ACME TOWNSHIP PLANNING COMMISSION MEETING
ACME TOWNSHIP HALL
6042 Acme Road, Williamsburg MI 49690
April 13, 2015, 7:00 p.m.

H. NEW BUSINESS: Traverse Bay RV Park Site Plan Review

Preliminary Review Comments

SAMPLE DRAINAGE CALCULATIONS:

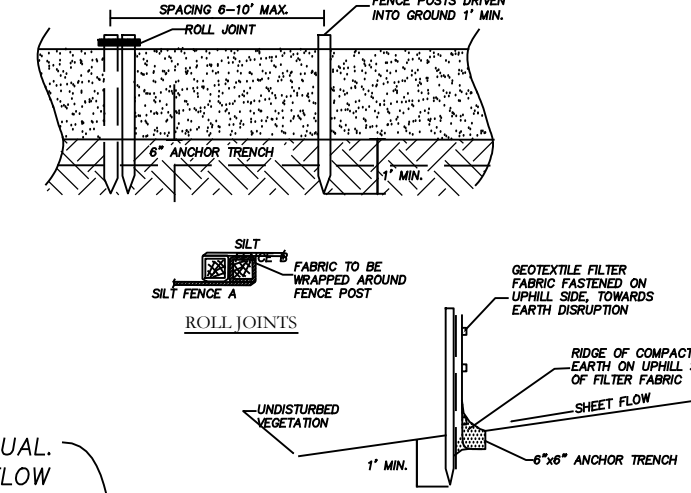
The impervious areas used in the calculations shown on the plans were checked. There are discrepancies in the impervious area used for each RV site between the calculations and plans. The typical lot site layout plans on sheet C-1 of the plans call out 2,200 sft of impervious area per lot. The calculations for each district use 1,800 sft per lot. The areas shown on sheet 3 of 10 scale to approximately 1,950 sft per lot. The revised calculations and plans need to match. **The calculations on the plans have been updated to us 2,200 sft of impervious area per lot.**
